REMARKS

AMENDMENTS TO THE DRAWINGS

Appl. No. 10/642,290 Atty. Dkt.: 2558-76 (formerly 978-72)-ANNOTATED SHEET

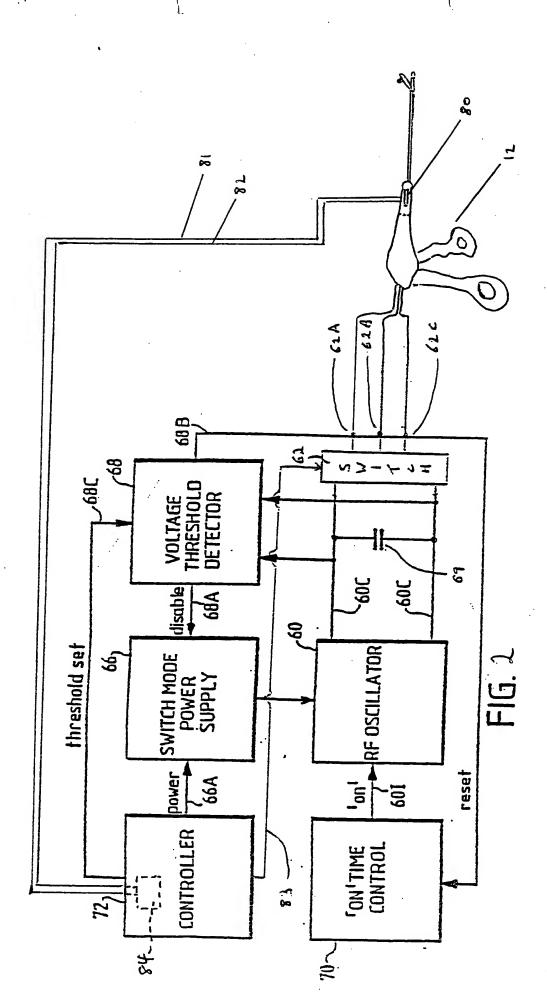
In Figure 11, sensing circuit 84 has been added, and is shown as being part of controller

- 72. In addition, previously omitted reference numerals --12, 80, 81 and 82 -- have been added.

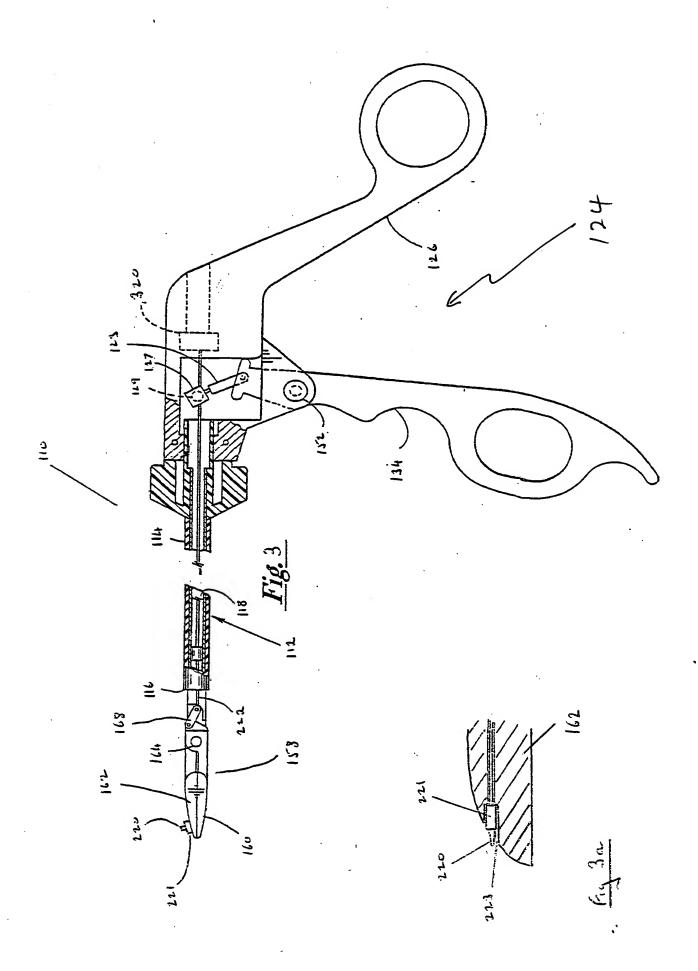
In Figure 12, sensing circuit 84 has been added, and is shown as being part of controller
- 72. In addition, previously omitted reference numerals -- 12, 80, 81 and 82 -- have been added.

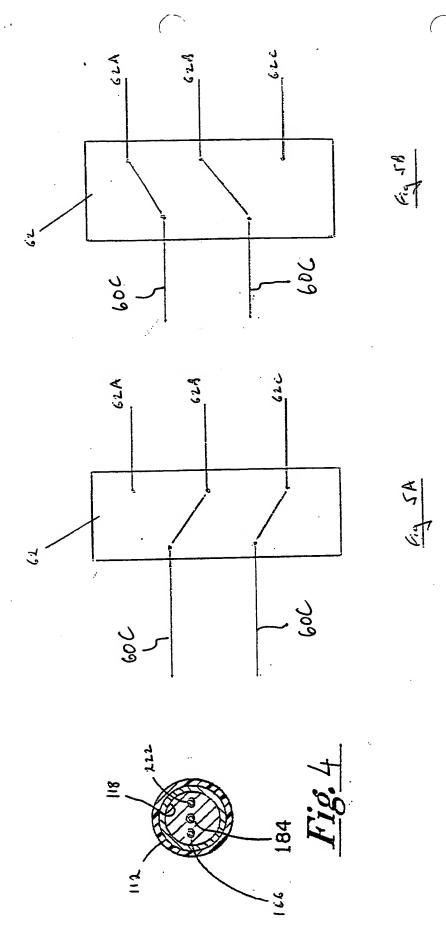
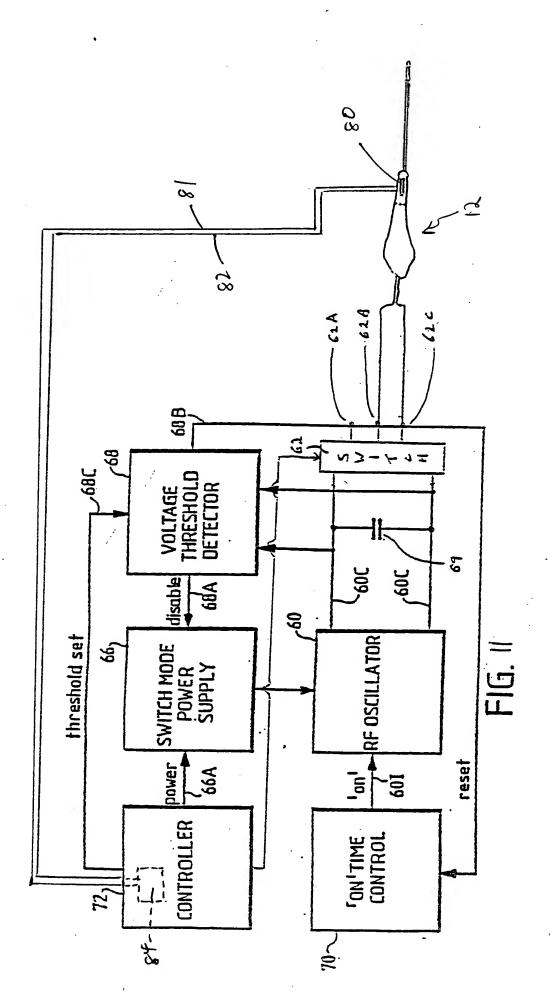
In Figure 2, sensing circuit 84 has been added, and is shown as being part of controller 72.

- In Figure 3, previously omitted reference numeral -- 124 -- has been added.
- In Figures 5A and 5B, previously omitted reference numerals -- 60C -- have been added.
